**DOCKET NO. W-03512A-06-0407**

**NOTICE OF FILING REBUTTAL**  
**TESTIMONY**

## Testimony of William F. Haney, P.E.

## Alternate Means of Connecting Milk Ranch Well to the Pine Water System

# Attachment WFH1

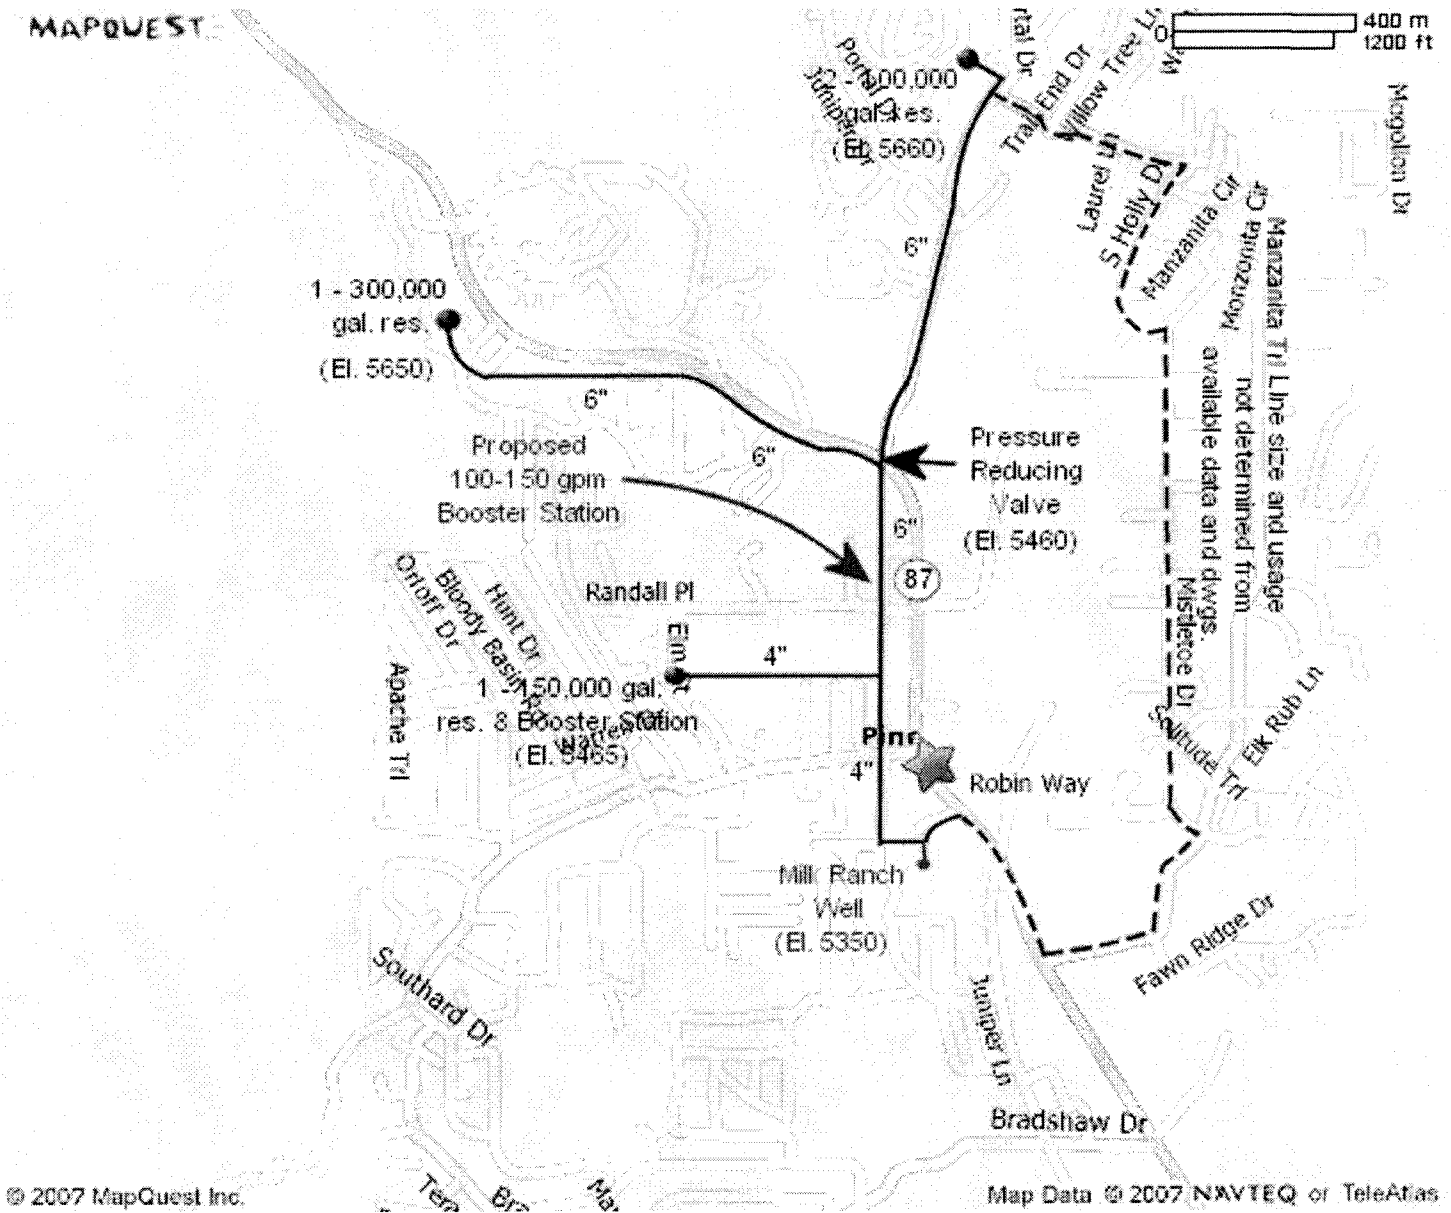
The layout directed by Hardcastle and estimated by Tetra Tech would install a booster station at the Milk Ranch site and an 8 inch pipeline from the well site to the 300K gallon tank in north Pine. While this layout will work and would be very simplistic to operate, in my opinion, it is a very high cost option when other options are available at a significantly lower cost to construct and would also result in substantially lower operating costs.

As indicated on Attachment WFH1, the existing distribution system (according to E&R System Maps dated 1987) has distribution lines (6 inch) running southeast along Hwy. 87 from the 300K tank to the intersection of the alignment of North Pine Creek Drive. The line then turns south and follows North Pine Creek to the southern property line of the community school. A 4 inch line then runs west to a 150,000 (150K) gallon tank at the end of Watertank Road. The north-south line also continues south on Pine Creek Drive as a 4 inch line to the intersection with North Road. At this point a line extends to the east across Pine Creek and is within 250 feet of the Milk Ranch Well. Milk Ranch could be connected at this point and could provide water to the 150K tank which in turn, supply's most, if not all of the water to Pine Water Company's service area to the south and west of Hwy. 87 (roughly half of the total service area). If a small

(100-150 GPM) booster station were installed somewhere on the 6 inch line north of the southern property line of the school on North Pine Creek Drive, then additional capacity from the well could be delivered to the northern pressure zone within the community. As the northern zone "floats" off of the 300K tank, any water entering that pressure zone would then be available for use in the entire system north and east of Hwy. 87 and water could also be delivered to Strawberry if needed.

A preliminary estimate of costs to accomplish the above would be approximately \$20,000 to connect Milk Ranch to the 4 inch line and between \$110,000 and \$150,000 to construct the small booster station.

It should also be noted that use of the 4 inch line to deliver 150 GPM of water would result in a flow velocity of 3.2 feet per second in the pipe. Good engineering practice dictates that velocities of less than 4 feet per second are desirable. Hence, use of the 4 inch line could easily accommodate production from the well. Also, by using the existing distribution system to move the water, only about half of the water would be pumped to the upper zone, thereby resulting in additional energy savings (under the BUI layout, all of the water would be pumped to the 300K tank and then much of that water would then flow back down the system through a pressure reducing valve and into the lower pressure zone and 150K tank). Finally, it should be noted that boosting the water would result in a significant increase in line pressures (approx. 80 psi) from the proposed booster station to the intersection of North Pine Creek Drive and Hwy. 87 and this segment of line may require rehabilitation/replacement if line breaks become a problem. All other segments of the system would continue to "float" on the existing storage reservoirs at existing system pressures.

While the layout will work and is very simplistic in concept, in my judgment it is a very costly and inefficient method of connecting the well. As previously stated, a design using a layout similar to Attachment WFH1 would utilize existing pipe and result in much lower operating expenses as only the water needed in the upper pressure zone would require booster pumping. Additionally, the most if not all, of the community south and west of Hwy. 87 could be served with minimal construction effort and water that was previously delivered from north to south could be retained in the upper pressure zone, thereby easing shortages there.

In addition to the above, use of an 8 inch line seems overkill and only adds to the cost of the project without providing benefit. While such size would be desirable for future fire protection as stated, it would be unusable for such purposes if the pipeline were a dedicated transmission main that discharged to the top of the 300K tank. No fire flow storage would be available under this scenario and only the well production would be available. If that same line connected to the bottom of the 300K tank, then it would be equally effective to merely connect the new pipeline to the existing at the intersection of North Pine Creek Drive and Hwy. 87, saving hundreds of thousands of dollars in pipeline costs.

Based upon the system layout indicated on the E&R Maps and available system hydraulics, the Milk Ranch Well is located in an excellent location for supplying nearly half of the service area with a simple connection to the existing system as described in my previous response. The entire system including Strawberry could be served by adding only a small booster station.

Connecting the well to the system with no other improvements would allow the Milk Ranch Well to serve most of the Pine Water service area west and south of Highway 87 for approximately \$20,000. This would also allow the remainder of the system to utilize well capacity freed up by Milk Ranch. While this one connection would not alleviate the long term supply in Pine, would provide some much needed, immediate relief for the customers.
